Prepared for
Health Infrastructure NSW

Submissions Report - SSD-96248991

New Rouse Hill Hospital

Figure 1 Car park northern elevation as exhibited (left) and as amended (right)
Source: HDR

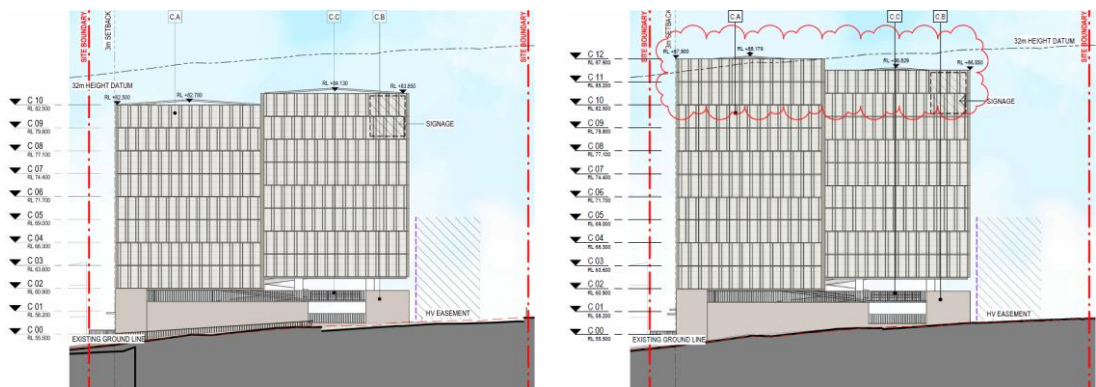
Health Infrastructure and Arup have reviewed the proposed provision of on-site car parking and have determined to add an additional 1.5 storeys to the multi-storey car park taking the roof ridgeline to RL 88.2m and the absolute height to RL 89.7m (refer to **Figure 1**). Updated Architectural Plans have been prepared by HDR and are provided at **Appendix C**. A total 744 spaces are provided in the multi-storey car park. A breakdown of the types of spaces is provided in **Table 3** below.

Figure 3 Amended Commercial Road right turn lane ancillary works

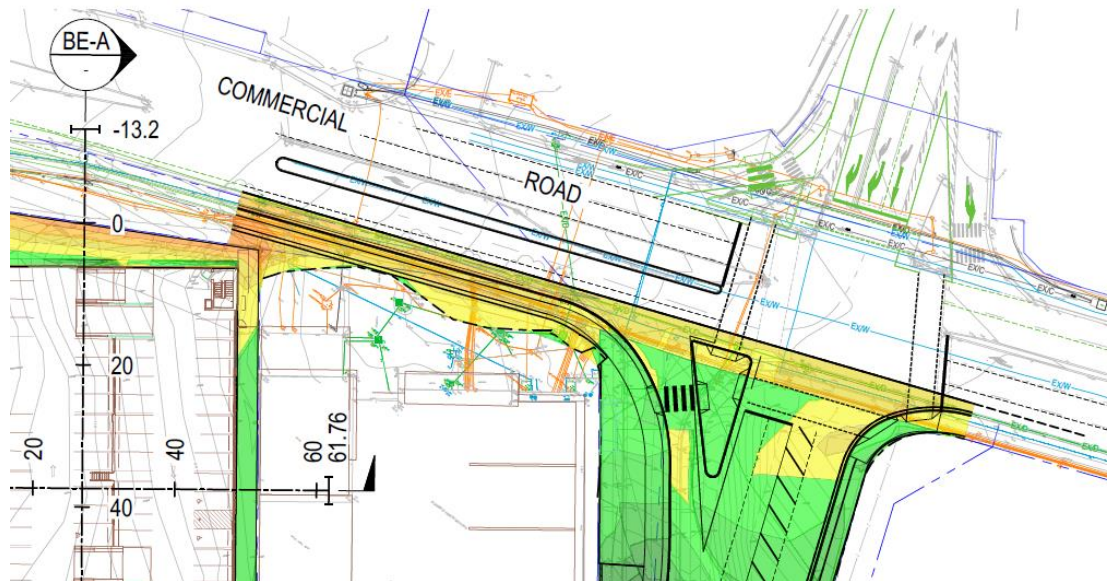
median. As outlined in **Section 3.3** and **Appendix D**, the Civil Plans prepared by Acor have been revised to incorporate refinements to the design and to provide clarification that the existing right-in and right-out arrangement to and from The Fiddler site is not impacted by the proposed Commercial Road ancillary works.

The Civil Plans prepared by Acor have been revised to incorporate refinements to the design of the new right-turn lane into Hospital Road, improving its connection to the existing roadway (see **Figure 3** below). The updated Civil Plans are provided at **Appendix D** to this report.

Figure 2 Approved Northern Precinct Road Hierarchy Plan (354/2013/HB)

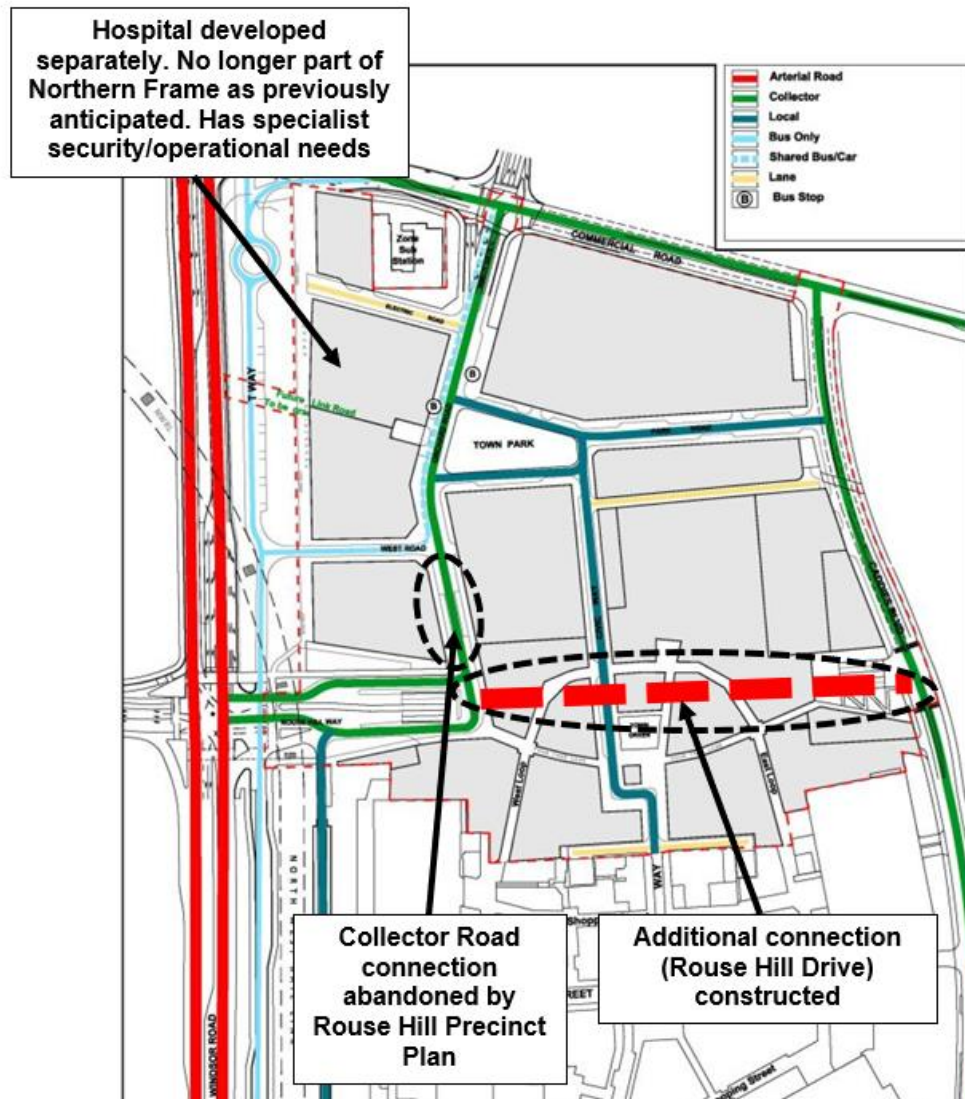
THSC assert that the proposal does not contain a detailed assessment against the Rouse Hill Regional Centre Masterplan approved under 1604/2004/HB (as amended) and Precinct Plan 354/2013/HB (referred to as 'the Masterplan' and 'the Precinct Plan' hereafter). For the avoidance of doubt, this is different to *Precinct Plan – Rouse Hill Strategic Centre* adopted by Council in November 2023.

The approved road layout proposed a vehicle connection from Windsor Road via Rouse Hill Way and “Hospital Road” (previously known as Orchard Road) to Commercial Road. This provided the only Collector Road north/south connection through the Northern Precinct (see **Figure 2** below). However, Rouse Hill Drive has been constructed to provide a more direct Collector Road north/south connection through the precinct inconsistent with the approved Masterplan.

The construction of Rouse Hill Drive provides a four lane connection between Rouse Hill Drive and Caddies Boulevard with signalised intersections at both ends and at the Civic Way connection into the Northern Frame Site. This connection not envisaged by the approved Northern Precinct Plan negates the need for the Park Road connection. Performance of the proposed road layout is discussed at **Section 4.2** above.

There are opportunities for The Northern Frame site to provide additional connections to Commercial Road, Caddies Boulevard and Rouse Hill Drive in the future.
